Access Compliance Report

Public Rights-of-Way

(Curb Ramps)

Intersection ID: N/A	Main Street: PHILLIPS_AV	Cross Street: MAYFLOWER_RD	Location: NW
ADA ID: 8FA0E12DEAD5	Ramp Type: Directional1	Initial Pass/Fail: Pass	Overall Compliance: No
		Severity Score: 2.5

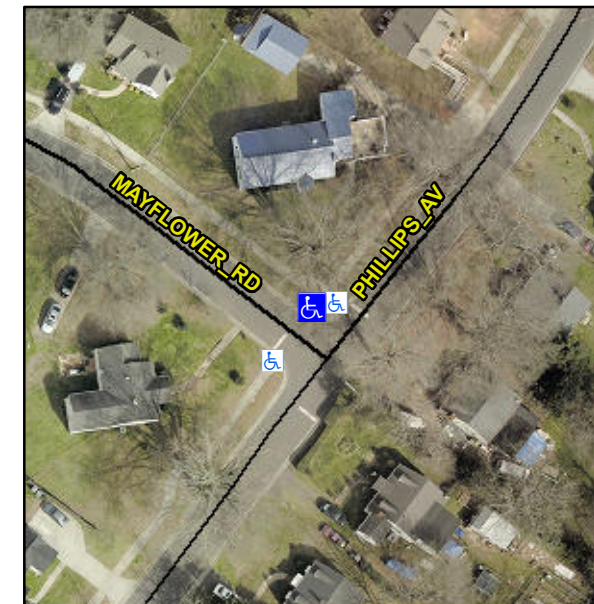
R304.5.3, R305.1.4, R305.2

Compliance	Description	Data	Compliance	Description	Data
N/A	Ramp Length (in)	136.0	Yes	Grade Break?	Yes
Yes	Ramp Width (in)	54.0	No	Grade Break Slope (%)	11.9
Yes	Ramp Slope (%)	5.4	Yes	Grade Break XSlope (%)	1.9
Yes	Ramp XSlope (%)	1.9			
Yes	Flare Type LT	N/A	Yes	Flare Type RT	N/A
N/A	Flare Slope LT (%)	N/A	N/A	Flare Slope RT (%)	N/A
N/A	Flare Traversable LT?	No	N/A	Flare Traversable RT?	No
Yes	Landing Length (in)	59.0	Yes	DWS Provided?	Yes
Yes	Landing Width (in)	59.0	Yes	DWS Contrast?	Yes
Yes	Landing Slope (%)	0.4	Yes	DWS Length (in)	24.0
Yes	Landing X Slope (%)	1.1	No	DWS Full Width?	No
N/A	Landing Curb? (Y/N)	N/A	Yes	DWS Offset LT (in)	5.0
N/A	Shared Landing?	Yes	No	DWS Offset RT (in)	2.5
Yes	Gutter Ponding?	No	Yes	Gutter Slope (%)	0.4
Yes	Gutter Lip Ht (in)	0.0	Yes	Gutter X Slope (%)	1.7
N/A	Painted X Walk1?	No		Road Slope (%)	0.4
	X Walk 1 Direction	To S		Road X Slope (%)	1.4
	X Walk 1 Width (in)	N/A		Clear Space?	Yes

Remove & Replace Entire Ramp.
